Gas Networks Statement of CONDITIONAL COMPLIANCE

MITCHELL CHILDCARE CENTRE
 BLOCK 18, SECTION 11 CORNER DARLINS &
 HEFFERNAN STREET MITCHELL ACT

Description: PROPOSAL FOR CHILDCARE CENTRE - construction of a new 3 storey childcare centre, new driveways, car park and dropoff area, landscaping and associated site works.

ACT Emergency Services Agency
Development Application Review

SECOND FLOOR PLAN

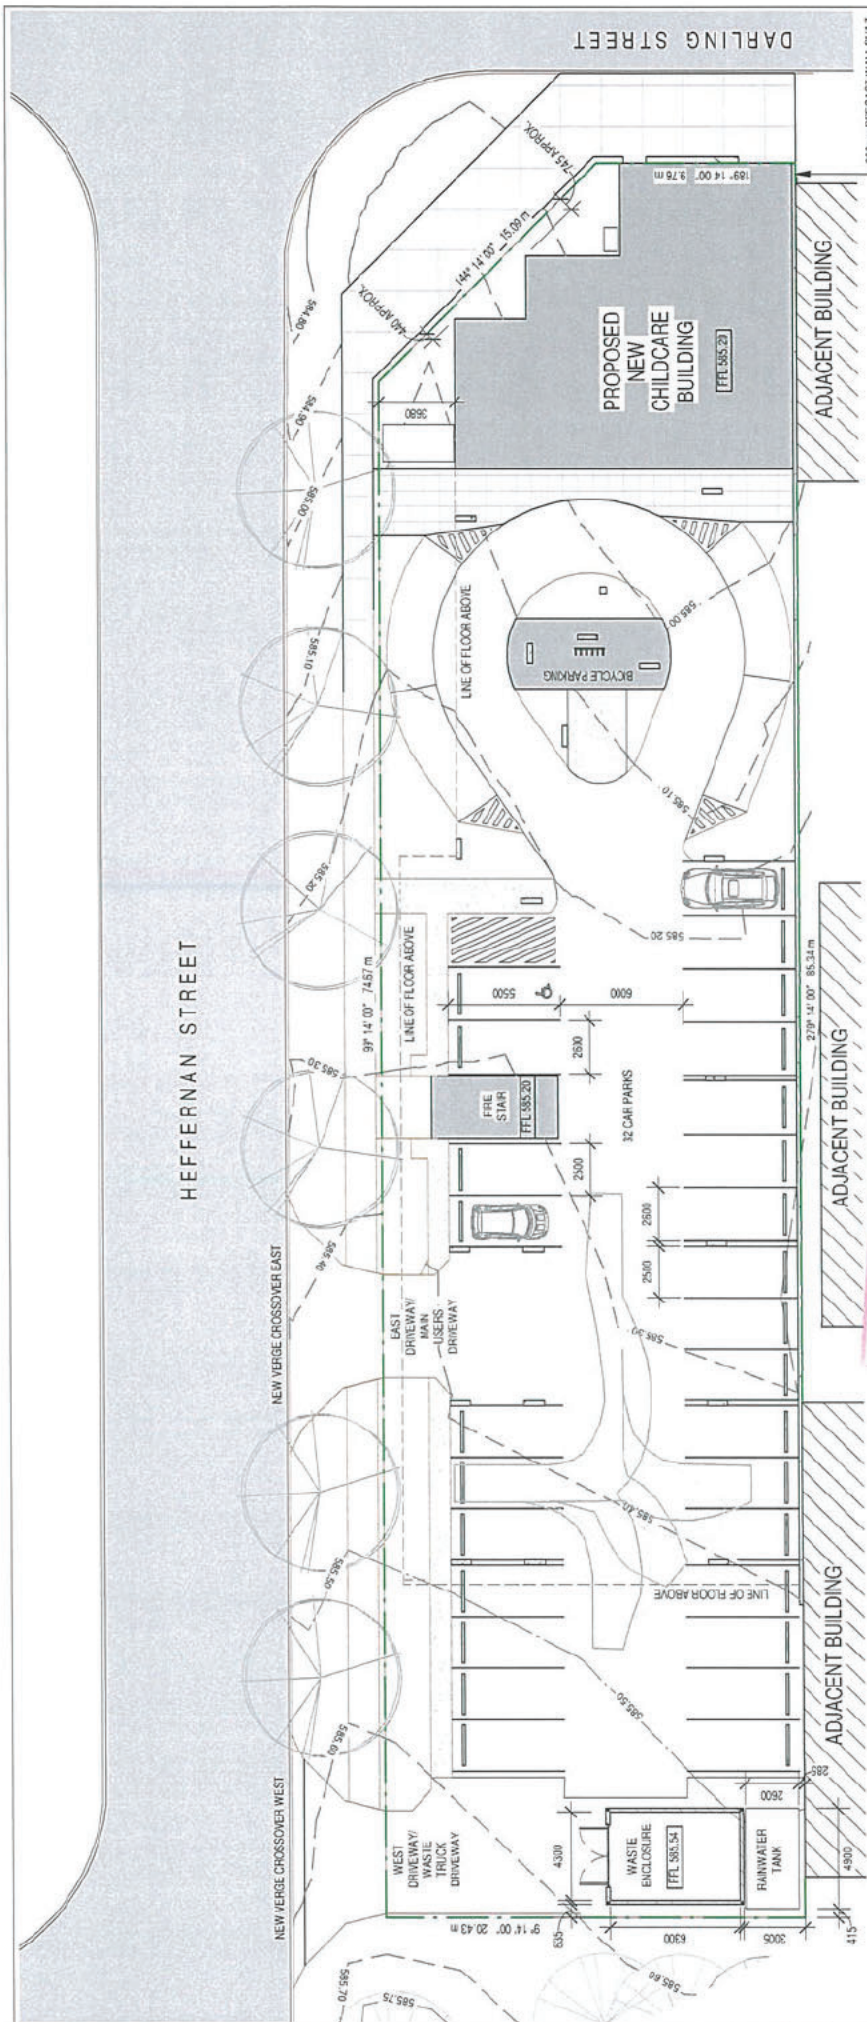
ActewAGL
Gas Networks

CONDITIONALLY COMPLIES

This document has been assessed against legislation protecting ActewAGL's infrastructure and access to it. The information contained in this application with ActewAGL's gas network protection access requirements is subject to the conditions on the Statement of Conditional Compliance.

2 WEST ELEVATION
1:250

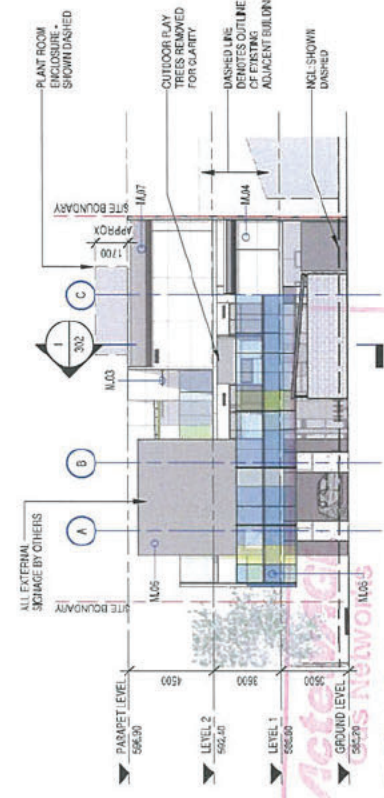
CONDITION 2 WEST ELEVATION IMPLIES

This document has been assessed against legislation protecting ActewAGL's infrastructure and access to it.

The information contained in this application complies with ActewAGL's gas network protection and access requirements subject to the conditions as listed on the Statement of Conditional Compliance.
